From: Howard Tong <[REDACTED]>
Sent: 03 February 2026 18:05
To: tpbpd/PLAND
Cc: [REDACTED]
Subject: s.16 Planning Application No. A/YL-KTS/1079 - Reply to Departmental Comment (FSD/DSD)
Attachments: Attachment 1 - Fire Services Proposal.pdf; Attachment 2 - Drainage Proposal.pdf; Attachment 3 - Colour Water Test Report on Existing Village Box Culvert.pdf; Attachment 4 - Table for the Hydraulic Design for Pipe, Sewers and Channel, A18.pdf; Attachment 5 - Letter from the Adjoining Owner of Lot TS 601.pdf
Categories: Internet Email

Refer to captioned Planning Application No. A/YL-KTS/1079, please find below our reply to departmental comments (FSD/DSD) for TPB consideration:

TRAINING CENTRE
LOTS NO. 602 S.B.(Part), 602 S.C.(Part), 602 R.P., 603 S.C.(Part), 603 S.D.(Part), 603 R.P.,
IN D.D. 106,
KAM SHING ROAD, KAM TIN, YUEN LONG.

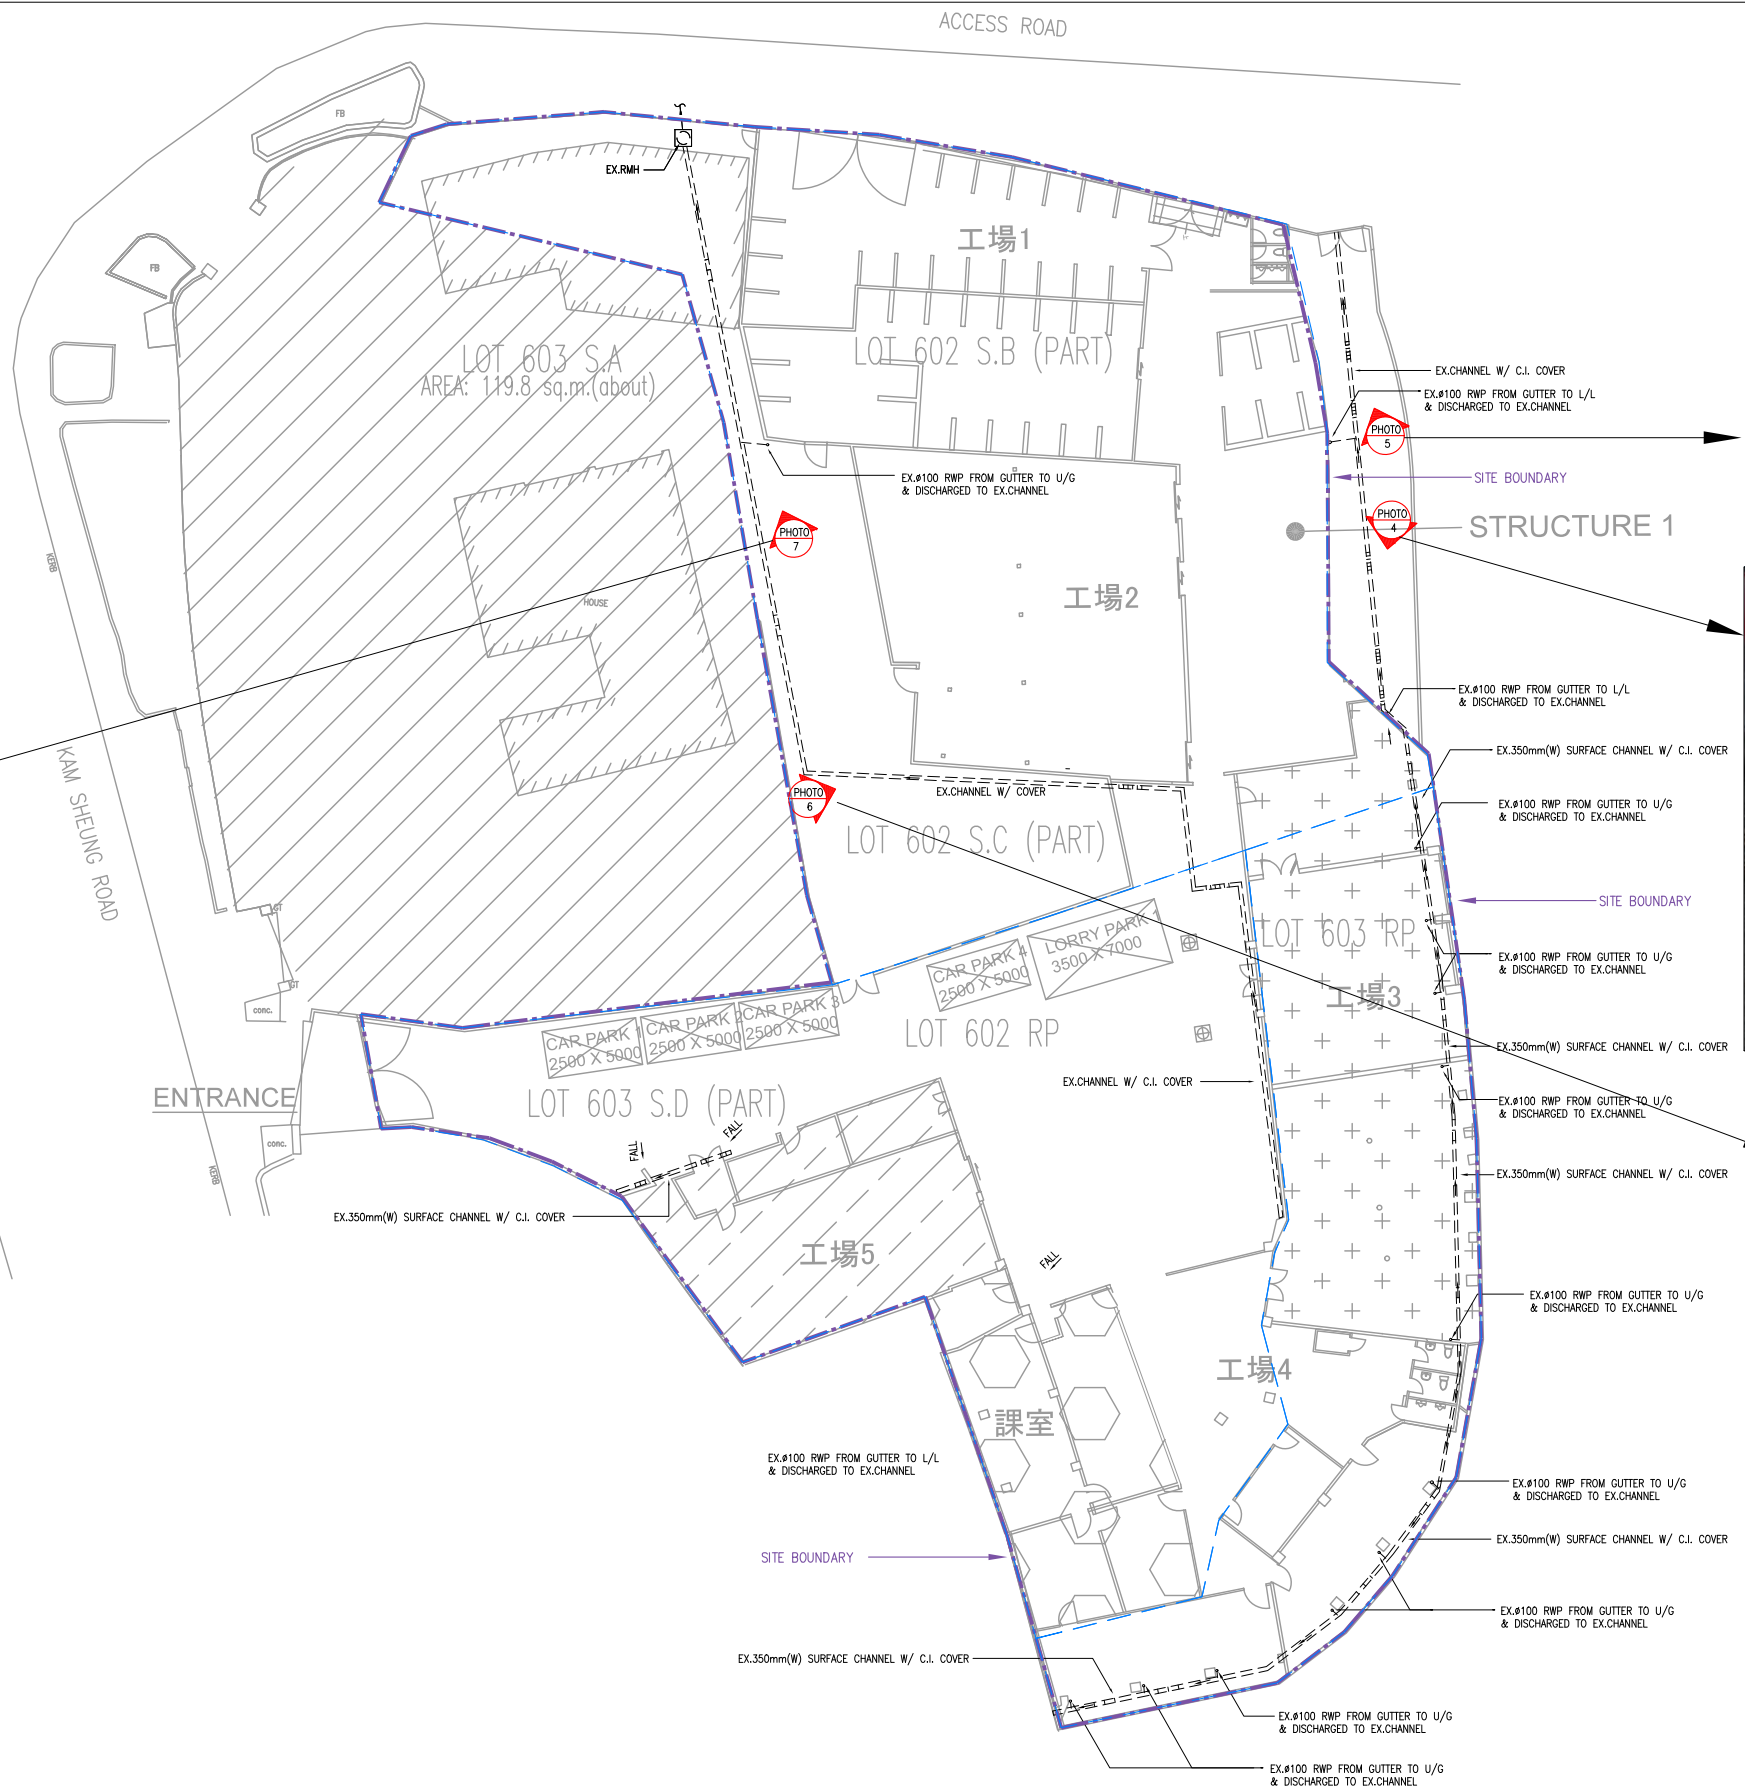
Please find attached Drainage Proposal - Item a) to d) to incorporate DSD comment:

5. Insufficient space to install new catchpit inside Lot 602 S.B. (Part) since it has been fully covered by existing building. After further coordination with Land Owner of "Lot TS 601", new catchpit ST-R-01 would be located inside "Lot TS 601" boundary area and share the use / maintenance of the new catchpit and surface channel. Agreement is attached for further consideration.

INSUFFACE SPACE TO INSTALL NEW CATCHPIT INSIDE LOT 602-S.B (PART) SINCE IT HAS BEEN FULLY COVERED BY EXISTING BUILDING. AFTER FURTHER COORDINATION WITH LAND OWNER OF "LOT-TS 601", NEW CATCHPIT ST-R-01 WOULD BE LOCATED INSIDE "LOT TS 601" BOUNDARY AREA AND SHARE USE/MAINTENANCE OF THE NEW CATCHPIT AND SURFACE CHANNEL. AGREEMENT IS ATTACHED FOR FURTHER CONSIDERATION

INSUFFACE SPACE TO INSTALL NEW CATCHPIT INSIDE LOT 602 S.B (PART) SINCE IT HAS BEEN FULLY COVERED BY EXISTING BUILDING. AFTER FURTHER COORDINATION WITH LAND OWNER OF "LOT TS 601", NEW CATCHPIT ST-R-01 WOULD BE LOCATED INSIDE "LOT TS 601" BOUNDARY AREA AND SHARE USE/MAINTENANCE OF THE NEW CATCHPIT AND SURFACE CHANNEL. AGREEMENT IS ATTACHED FOR FURTHER CONSIDERATION
